Access Compliance Report

Public Rights-of-Way

Intersection ID: N/A	Main Street: DIXIE_RIVER_RD	Cross Street: N/A	Location: NE
ADA ID: 27ED902A3156	Ramp Type: BlendTrans1	Initial Pass/Fail: Pass	Overall Compliance: No
		Severity Score: 0

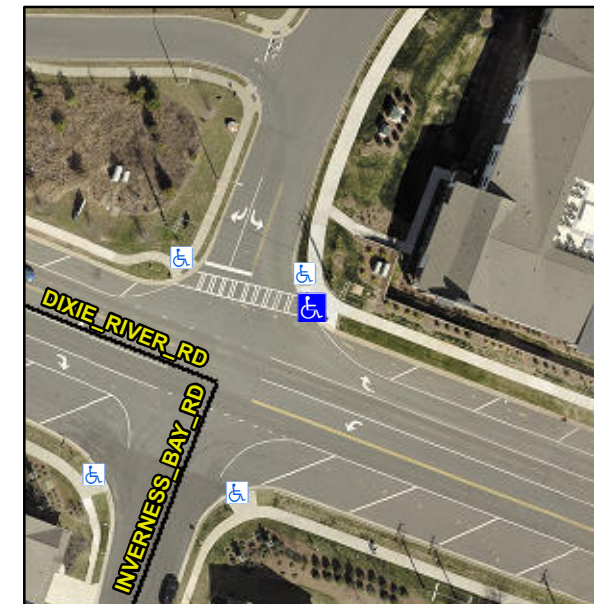
R305.2, R304.5.3

Remove & Replace Detectable Warning System. Remove & Replace Gutter.
